## ArevaEPRDCPEm Resource

**From:** WILLIFORD Dennis (AREVA) [Dennis.Williford@areva.com]  
**Sent:** Thursday, July 07, 2011 1:49 PM  
**To:** Tesfaye, Getachew  
**Cc:** BENNETT Kathy (AREVA); DELANO Karen (AREVA); ROMINE Judy (AREVA); RYAN Tom (AREVA); Miernicki, Michael  
**Subject:** Response to U.S. EPR Design Certification Application RAI No. 376, FSAR Ch. 3, Supplement 24  
**Attachments:** RAI 376 Supplement 24 Response US EPR DC - PUBLIC - Part 1 of 2.pdf

**From:** WILLIFORD Dennis (RS/NB)  
**Sent:** Monday, June 27, 2011 4:47 PM  
**To:** Tesfaye, Getachew  
**Cc:** BENNETT Kathy (RS/NB); DELANO Karen (RS/NB); ROMINE Judy (RS/NB); RYAN Tom (RS/NB); CORNELL Veronica (External RS/NB)  
**Subject:** Response to U.S. EPR Design Certification Application RAI No. 376, FSAR Ch. 3, Supplement 23

Figure 3.7.1-33—Input Motion for Structures not on the Nuclear Island Common Basemat, Horizontal Motion  
5% Damping (EUR)

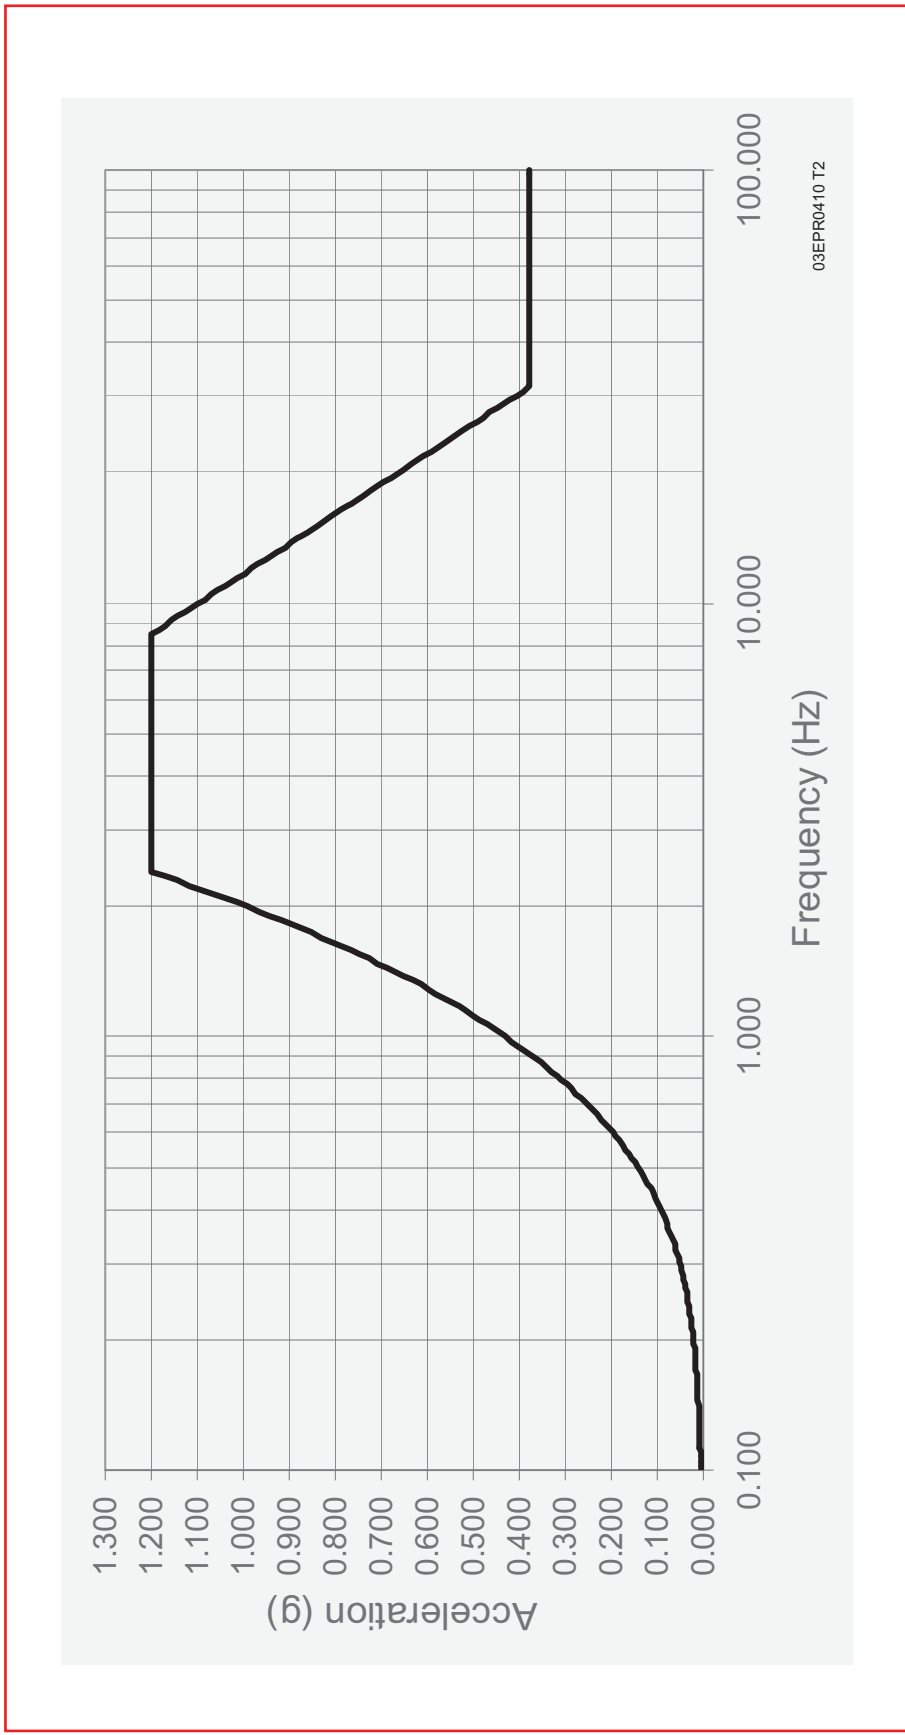
Figure 3.7.1-33—Input Motion for Structures not on the Nuclear Island Common Basemat, Horizontal Motion 5% Damping (EUR) and Figure 3.7.1-34—Input Motion for Structures not on the Nuclear Island Common Basemat, Vertical Motion 5% Damping (EUR); show the ~~modified~~ input motion obtained by modifying the EUR control motions, identified as SSSI motion, for the Seismic Category I Structures that are not on the NI Common Basemat, ~~and Section 3.7.2.4 describes the basis for the development of these spectra in more detail. This input motion does not constitute a second seismic design basis (i.e., a second set of CSDRS); rather it is the logical extension of the seismic design basis CSDRS to provide input motion to structures not on the common basemat.~~ Figure 3.7.1-49—Input Motion for Structures Not on the NI Common Basemat, Horizontal (SSSIHF) and Figure 3.7.1-50—Input Motion for Structures Not on the NI Common Basemat, Vertical (SSSIHF) show the high frequency input motion obtained by modifying the HF control motion, identified as SSSIHF motion, for the ESWB and EPGB. These input motions do not constitute an additional seismic design basis (i.e., a second set of CSDRS); they are the logical extension of the seismic design basis CSDRS that provide input motion to structures not on the common basemat.

Figure 3.7.1-41—Cumulative Energy Plot for Time Histories for Structures not on the Nuclear Island Common Basemat (EUR)

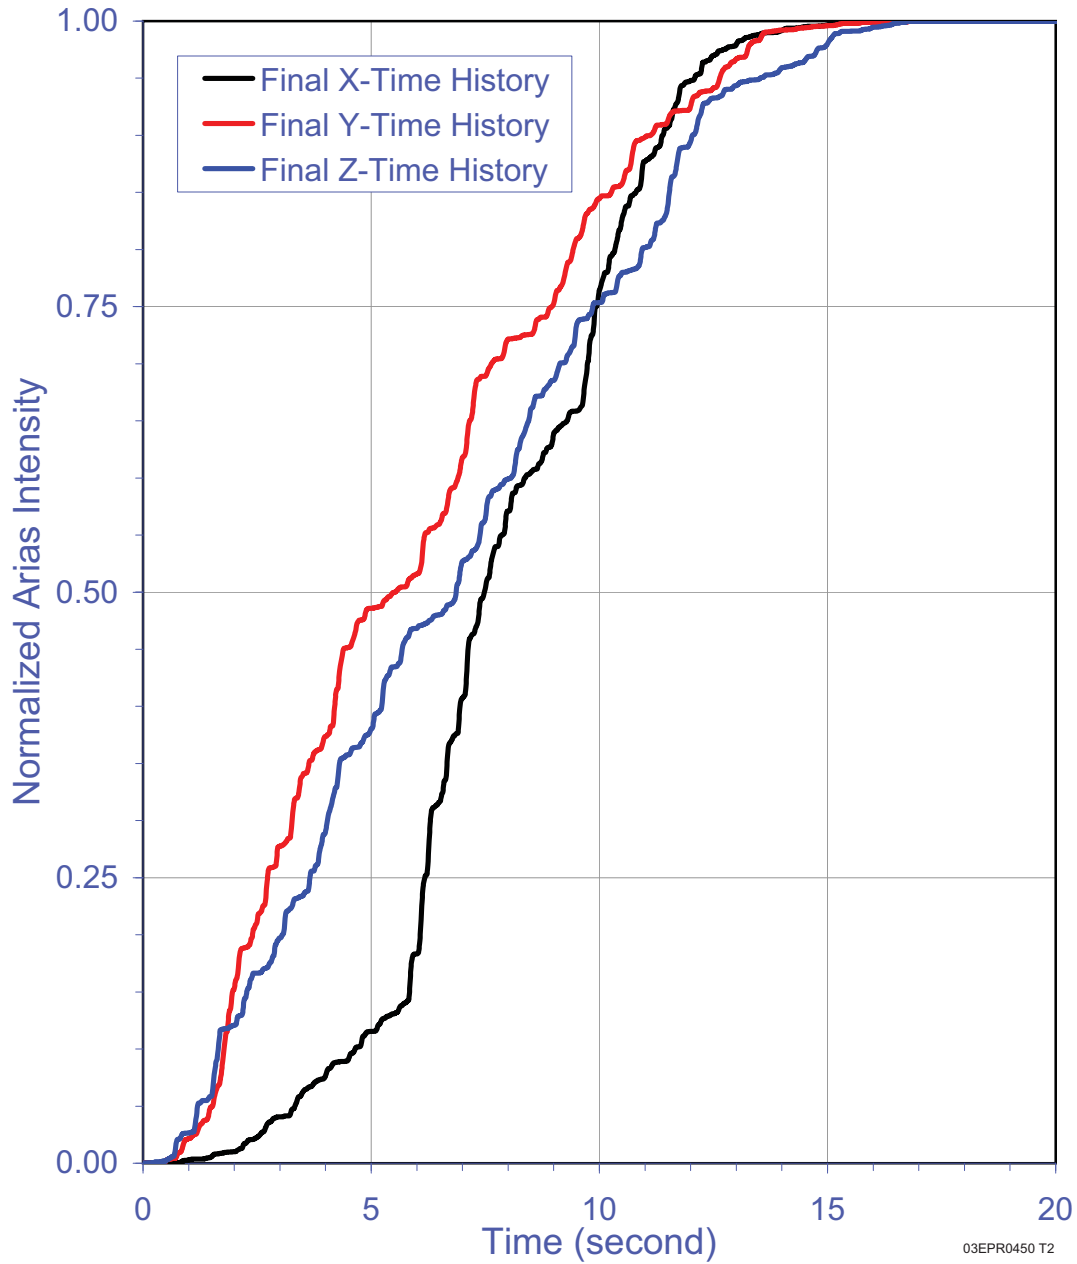
vs. Input Spectrum for Structures not on the Nuclear Island Common Basemat, Horizontal (SSSI3HF) Component, Figure 3.7.1-41—Cumulative Energy Plot for Time Histories for Structures not on the Nuclear Island Common Basemat (EUR), and Figure 3.7.1-59—Cumulative Energy Plot for Time Histories for Structures not on the Nuclear Island Common Basemat (HF). The five percent damped response spectra in Figures 3.7.1-17 through 3.7.1-25 compare the respective response spectra for the three time history sets for the EUR control motions to the corresponding smooth CSDRS target spectrum. ~~An internal AREVA code, RESPEC~~An AREVA code, RESPEC, Version 1.1A, is used to compute these response spectra. Figure 3.7.1-38 thru 3.7.1-40 provide a similar comparison for the time history ~~set used for the Seismic Category I structures not on the NI Common Basemat~~for the SSSI motion. The computer program BSIMQKE (Reference 8) is used to compute response spectra for this time history set. Similar comparisons for the HF and SSSIHF control motions are shown in Figure 3.7.1-45 through Figure 3.7.1-47 and Figure 3.7.1-56 through Figure 3.7.1-58, respectively. For all of these comparisons the response spectra are computed at a minimum of 100 points per frequency decade, uniformly spaced over the log frequency scale from 0.1 Hz to 50 Hz, or the Nyquist frequency. These figures show that the spectra satisfy the recommended guidelines for response spectrum enveloping. Bounding envelopes shown on these plots also demonstrate that the five percent damping response spectrum of each synthetic time history does not exceed the corresponding target spectrum by more than 30 percent nor does it fall below by more than 10 percent of the target.

Figures 3.7.1-26 to 3.7.1-28, ~~and~~ Figure 3.7.1-41, Figure 3.7.1-48, and Figure 3.7.1-59 show the Arias intensity function (or Cumulative Energy function) and the strong motion duration of each synthetic time history in the five percent to 75 percent Arias intensity. The strong motion durations calculated for the EUR-HF, SSSI, and SSSIHF time histories are shown in Table 3.7.1-3—Strong Motion Duration of Synthetic Time Histories. The minimum strong motion duration is six seconds, which meets the guideline in SRP Section 3.7.1 (Reference 6).

Figure 3.7.1-58—Time History Response Spectrum vs. Input Spectrum for Structures not on the Nuclear Island Common Basemat, Horizontal (SSSI3HF) Component

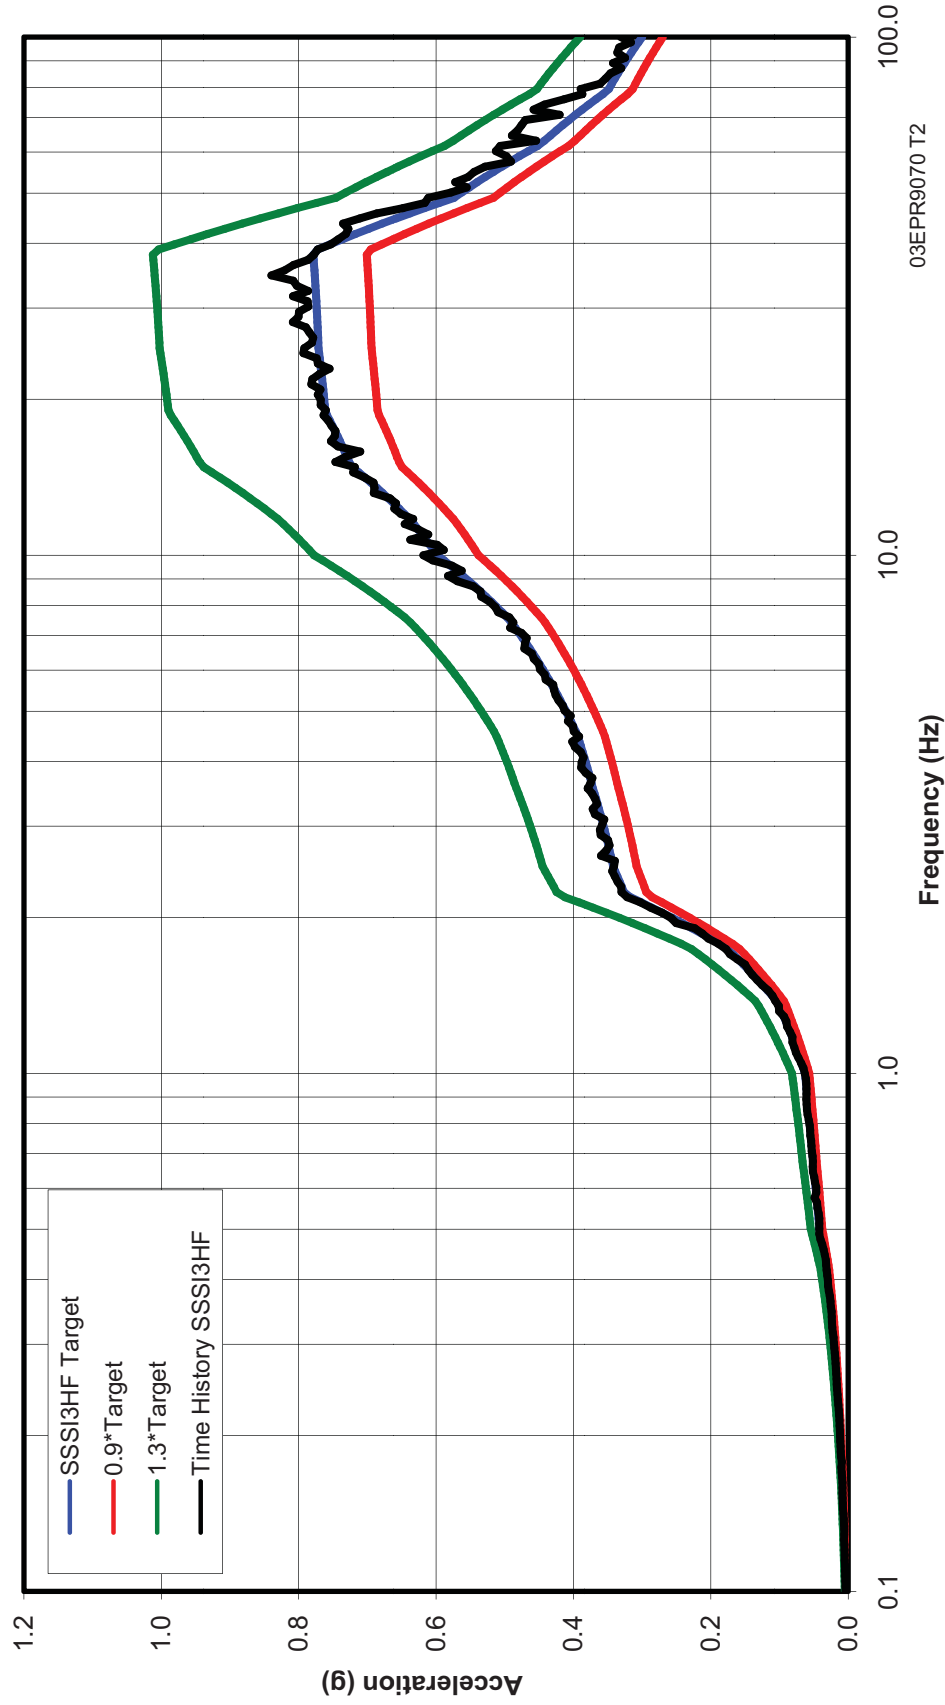
For each component, the CARES ~~code~~ SIMOKE, BSIMOKE, and AFIT codes generates the synthetic time history in which response spectra achieve approximately a mean-based fit to the target design spectra. Compliance with the preceding acceptance criteria is demonstrated in Figure 3.7.1-17—Response Spectrum of Time History H1 vs. Target Spectrum for EUR Hard Motion (TH1 Target, 1.30\*Target and 0.90\*Target at 5% Damping), Figure 3.7.1-18—Response Spectrum of Time History H2 vs. Target Spectrum for EUR Hard Motion (TH2 Target, 1.30\*Target and 0.90\*Target at 5% Damping), Figure 3.7.1-19—Response Spectrum of Time History H3 (Vertical) vs. Target Spectrum for EUR Hard Motion (TH3 Target, 1.30\*Target and 0.90\*Target at 5% Damping), Figure 3.7.1-20—Response Spectrum of Time History H1 vs. Target Spectrum for EUR Medium Motion (TH1 Target, 1.30\*Target and 0.90\*Target at 5% Damping), Figure 3.7.1-21—Response Spectrum of Time History H2 vs. Target Spectrum for EUR Medium Motion (TH2 Target, 1.30\*Target and 0.90\*Target at 5% Damping), Figure 3.7.1-22—Response Spectrum of Time History H3 (Vertical) vs. Target Spectrum for EUR Medium Motion (TH3 Target, 1.30\*Target and 0.90\*Target at 5% Damping), Figure 3.7.1-23—Response Spectrum of Time History H1 vs. Target Spectrum for EUR Soft Motion (TH1 Target, 0.90\* Target and 1.30\*Target at 5% Damping), Figure 3.7.1-24—Response Spectrum of Time History H2 vs. Target Spectrum for EUR Soft Motion (TH2 Target, 1.30\*Target and 0.90\*Target at 5% Damping), Figure 3.7.1-25—Response Spectrum of Time History H3 (Vertical) vs. Target Spectrum for EUR Soft Motion (TH3 Target, 1.30\*Target and 0.90\*Target at 5% Damping), Figure 3.7.1-45—Response Spectrum of Time History H1 vs. Target Spectrum for HFH Motion (TH1 Target, 0.90\* Target and 1.30\*-Target at 5% Damping)., Figure 3.7.1-46—Response Spectrum of Time History H2 vs. Target Spectrum for HFH Motion (TH2 Target, 1.30\* Target and 0.90\*-Target at 5% Damping)., Figure 3.7.1-47—Response Spectrum of Time History H3 (Vertical) vs. Target Spectrum for HFV Motion (TH3 Target, 1.30\* Target and 0.90\*-Target at 5% Damping). Figure 3.7.1-26—Cumulative Energy Ratio Plot for Time History H1, H2, and H3 for EUR Hard Motion, Figure 3.7.1-27—Cumulative Energy Ratio Plot for Time History H1, H2, and H3 for EUR Medium Motion, Figure 3.7.1-28—Cumulative Energy Ratio Plot for Time History H1, H2, and H3 for EUR Soft Motion, Figure 3.7.1-48—Cumulative Energy Ratio Plot for Time History H1, H2, and H3 for HF Motion. Figure 3.7.1-38—Time History Response Spectrum vs. Input Spectrum for Structures not on the Nuclear Island Common Basemat, Horizontal (SSSI1) Component, Figure 3.7.1-39—Time History Response Spectrum vs. Input Spectrum for Structures not on the Nuclear Island Common Basemat, Horizontal (SSSI2) Component, Figure 3.7.1-40—Time History Response Spectrum vs. Input Spectrum for Structures not on the Nuclear Island Common Basemat, Vertical (SSSI3) Component, and Figure 3.7.1-56—Time History Response Spectrum vs. Input Spectrum for Structures not on the Nuclear Island Common Basemat, Horizontal (SSSI1HF) Component, Figure 3.7.1-57—Time History Response Spectrum vs. Input Spectrum for Structures not on the Nuclear Island Common Basemat, Horizontal (SSSI2HF) Component, Figure 3.7.1-58—Time History Response Spectrum
